RC102 Remote Control Panel**Unintentional activation of self-test on RC102 RCP****1. PLANNING INFORMATION****A. Effectivity**

This Service Bulletin describes the procedure to modify the installation of RC102 RCP wiring.

Figure 1: Diagram of connection

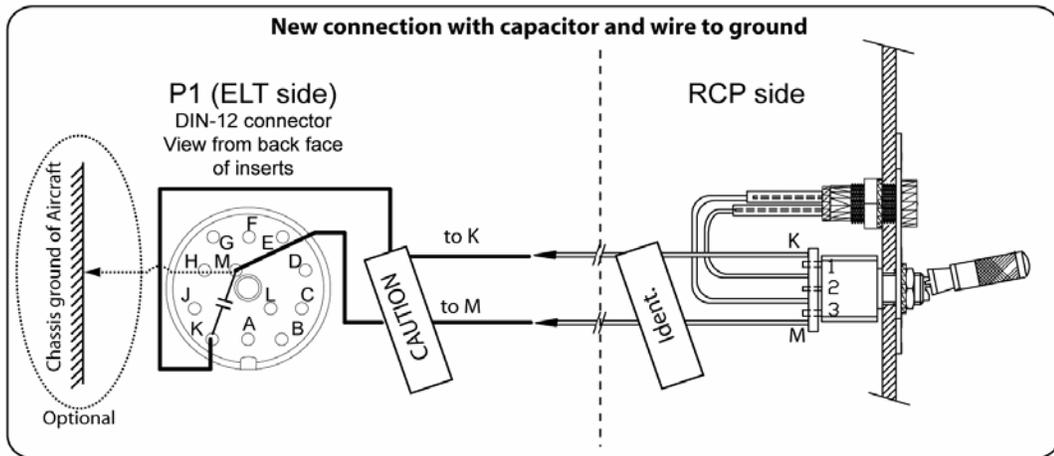
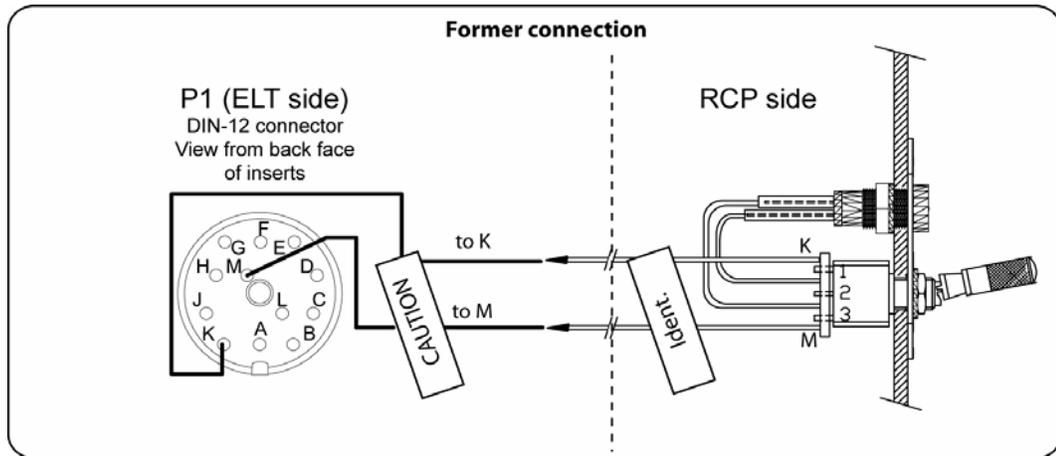
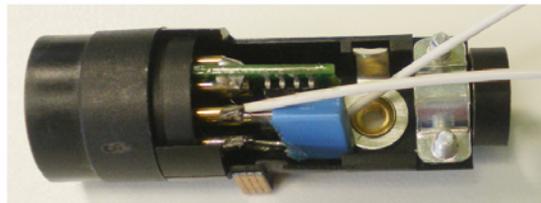
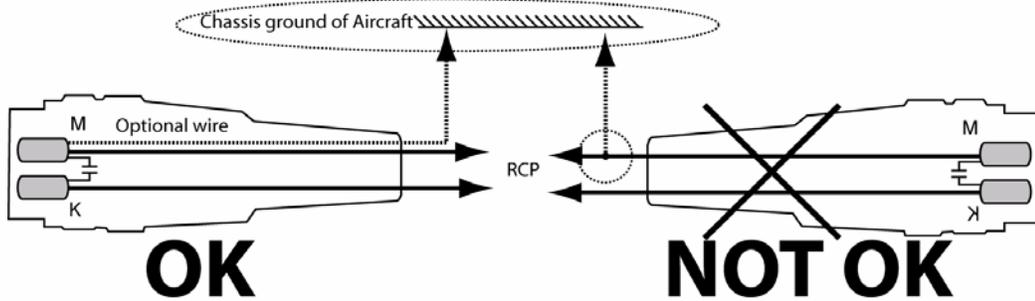
This problem can be solved by soldering a 100 nF capacitor between pin M and pin K in the DIN-12 connector of the ELT and eventually connecting pin M of the DIN-12 connector to the chassis ground of the aircraft as close as possible to the ELT.

- (1) Disconnect DIN-12 connector on the ELT side.
- (2) Disassemble the DIN-12 connector supplied with the ELT.
- (3) Solder the 100 nF capacitor between pin M and Pin K of DIN-12 connector.
- (4) Reassemble the DIN-12 connector.
- (5) Connect the DIN-12 connector to the DIN-12 receptacle of the ELT.
- (6) Check the installation by following the procedure described in [Section C. Reason](#).
- (7) If unintentional self-tests still occur, an **optional** additional wire must be connected to the chassis ground of the aircraft.

- (a) Identify a chassis ground of the aircraft as close as possible to the ELT.
 - (b) Pass a wire long enough to reach the chassis ground through the cap of the DIN-12 connector.
 - (c) Solder one end of the wire to pin M of DIN-12 connector, connect the other end to the chassis ground.
IMPORTANT: The additional wire has to be connected to the leg of the capacitor.
- (8) Check the installation by following the procedure described in [Section C. Reason](#).
 - (9) Perform RCP operational tests ([Refer to Figure 2: RCP Operational Test](#)).

IMPORTANT: the optional additional wire has to be soldered to the leg of the capacitor.
